Considered Opinion

Marina East

Public Art Installation

24 April 2020

AS1428.4.1 2009 Figure 2.6(A) and (B)

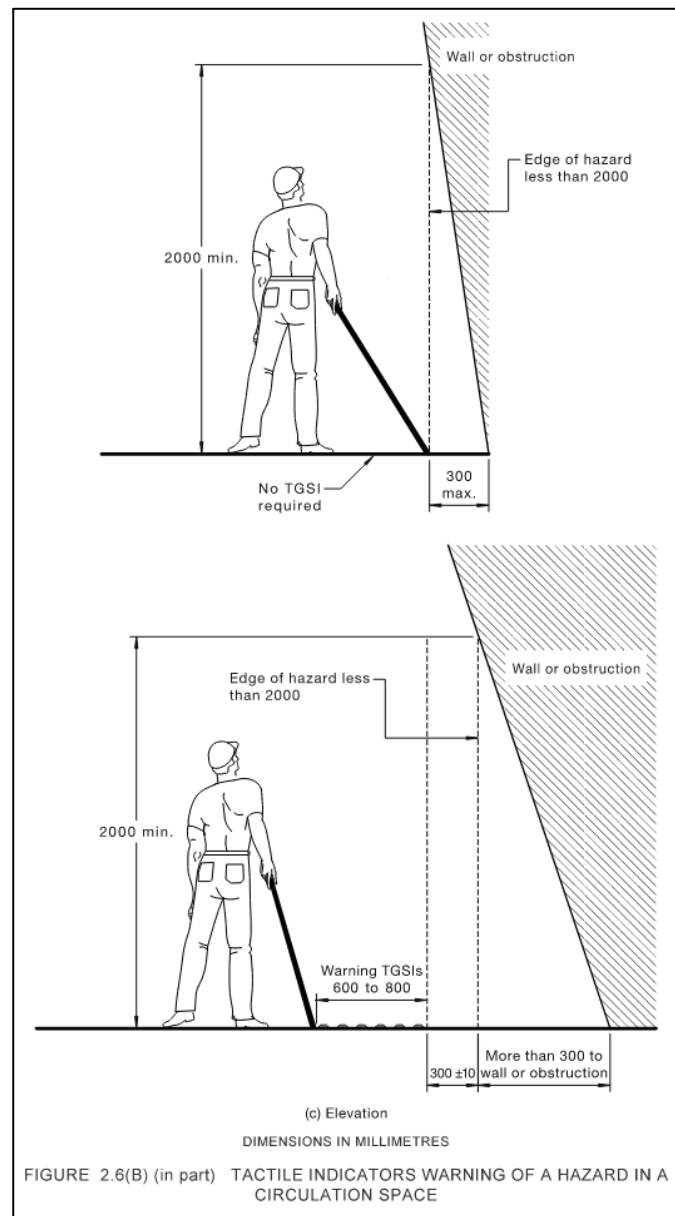
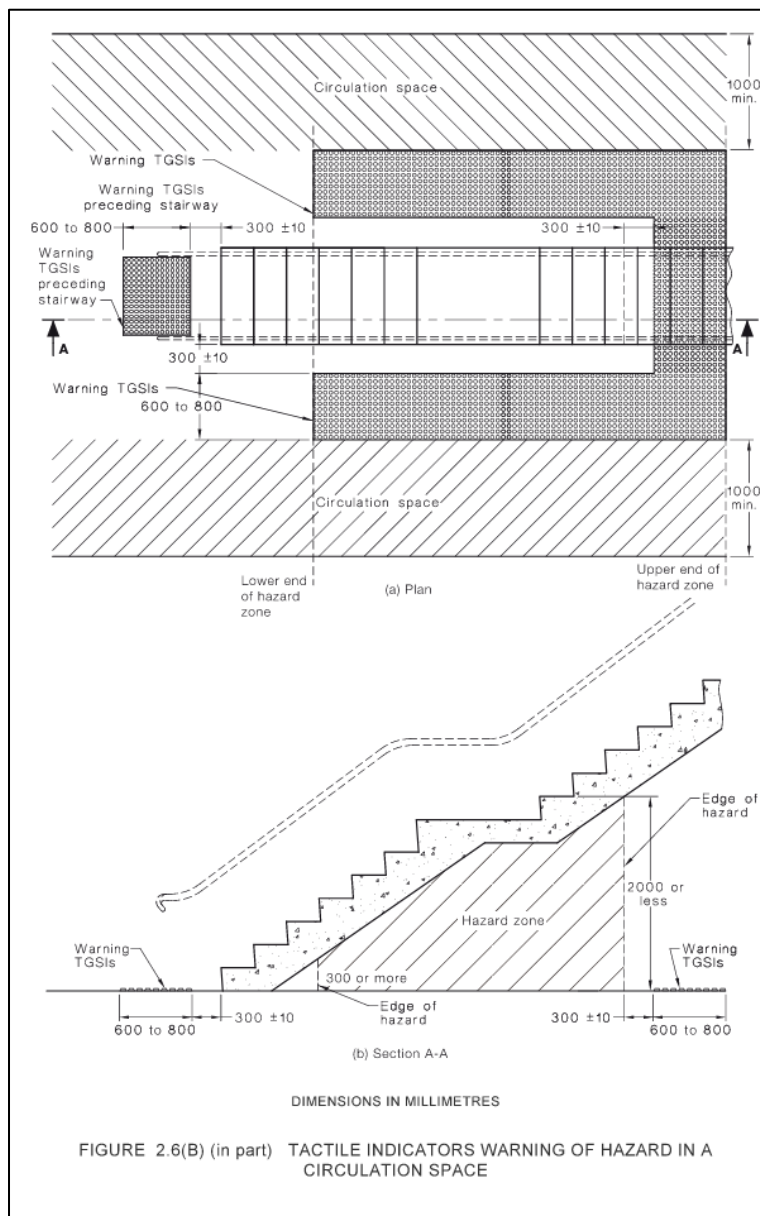
Warning style tactile ground surface indicators (TGSIs) are a valid and compliant solution to address the hazard. If this approach is adopted, the warning TGSIs installation would need to be in the same arrangement as depicted in AS1428.4.1 2009 Figure 2.6(A) and (B) (*replicated below*).

That is, for any component of the artwork protruding for more than 300mm and within the height range less than 2000mm, warning TGSIs would be required to be installed to effectively “enclose” the hazard. This could be delivered in two ways. Firstly, install warning TGSIs only around the elements that protrude by more than 300mm, or, alternatively, enclose the entire artwork with warning TGSIs at ground level, set 300mm off the protruding parts of the artwork, that is:

- Installed in a non-uniform pattern, to match the line of the artwork; or
- Installed 300mm off the furthest protruding part, i.e. 700mm plus 300mm and enclose the artwork with a rectangle shape of warning TGSIs.

As conveyed by Mr Attiwell, any installed TGSIs would need to be installed in the required 30% luminance contrast and to the set out /depth of AS1428.1 2009 Clause 2.3 and 2.6.

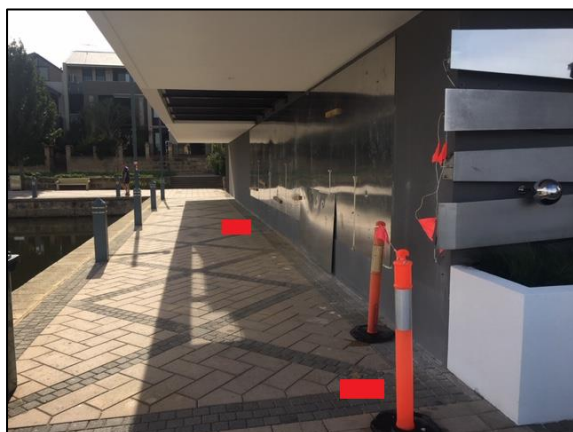
I have considered the additional strategy of installing a bollard at the ends and corner of the wall-mounted artwork, in combination with the laying of the warning tactile ground surface indicators. Mr Fitzgerald has proposed use of the same bollards that are used throughout the precinct and I find this will certainly provide an additional safety measure for people who are blind or vision impaired and others.

Mr Fitzgerald has proposed bollards be installed in combination with the warning style tactile ground surface indicators, as indicated in the photos below:

The red squares indicatively represent the proposed location for the bollards.

The bollards will match the existing bollards, which at 1.2 metres high, finished in a matt blue colour, will ensure information is conveyed to pedestrians in both a tactual and visual manner.
